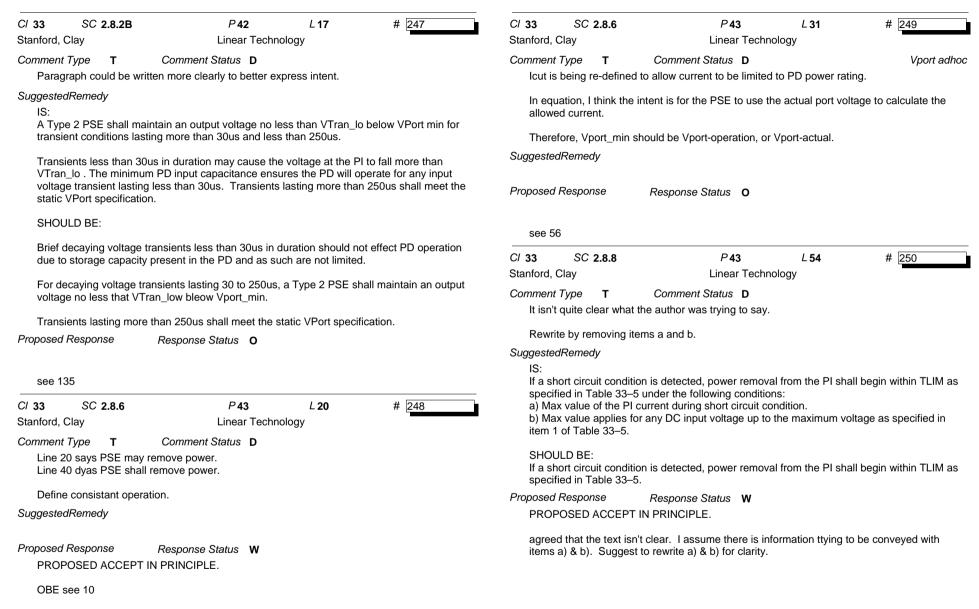
FOR T BELOV roposed / Agree, installa / 33 tanford, C comment Talks a Doesn	TYPE 1 OPERA W THE CABLE Response , except AF did ations at 60C at SC 1.5 Clay Type T about DC loop	TION, THE CABLE AMBIENT TEMPERATURE RATING. <i>Response Status</i> <b>O</b> not have a temp derating sper mbient non-compliant? <i>P</i> <b>17</b> Linear Techn <i>Comment Status</i> <b>D</b> resistance to be less than 25 of	c. Does adding t <i>L</i> <b>47</b> ology	his text make present	PSEs. Follow style of page 27 SuggestedRemedy Add new variable pse_i pse_available_power2 This variable indicates determined in an imple Values: 0: Class 1 1: Class 2 2: Class 0, Class 3 3: Class 4	, line 35, creating pse_availa availablepower2 the highest power PD Class	able_power2.	
FOR T BELOV roposed i Agree, installa <b>7 33</b> tanford, C comment Talks a Doesn uggested	TYPE 1 OPERA W THE CABLE Response , except AF did ations at 60C an SC 1.5 Clay Type T about DC loop n	TION, THE CABLE AMBIENT TEMPERATURE RATING. <i>Response Status</i> <b>O</b> not have a temp derating sper mbient non-compliant? <i>P</i> <b>17</b> Linear Techn <i>Comment Status</i> <b>D</b> resistance to be less than 25 of	c. Does adding t <i>L</i> <b>47</b> ology	his text make present	PSEs. Follow style of page 27 SuggestedRemedy Add new variable pse_i pse_available_power2 This variable indicates determined in an imple Values: 0: Class 1 1: Class 2 2: Class 0, Class 3 3: Class 4 SHOULD BE:	, line 35, creating pse_availa availablepower2 the highest power PD Class mentation-specific manner.	able_power2.

I had this same question. It was explained to me that loop resistance is 1 wire down and one wire back (and not a pair down and back). Therefore 25 ohms is correct.
